Technical Pages

The start relays provided with HOMA 1-phase pumps have changed. This document will explain the differences.

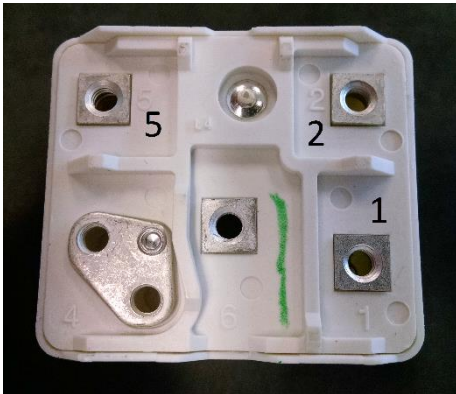
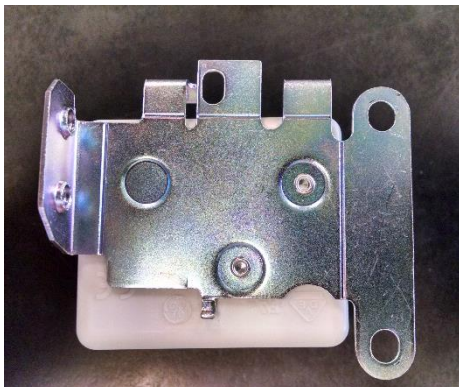
HOMA 1-phase pumps use three terminals: 1, 2, and 5.  
The current relay has five terminals, but terminals 4 and 6 are not used.

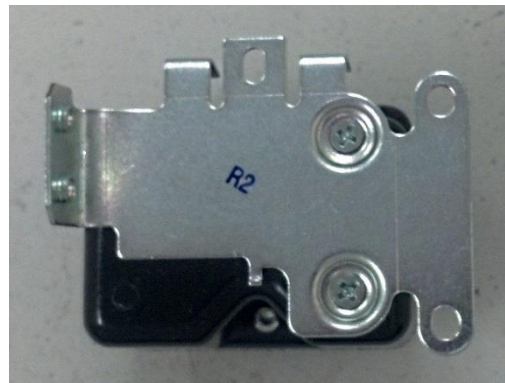
The current relay uses a slightly different style mounting bracket
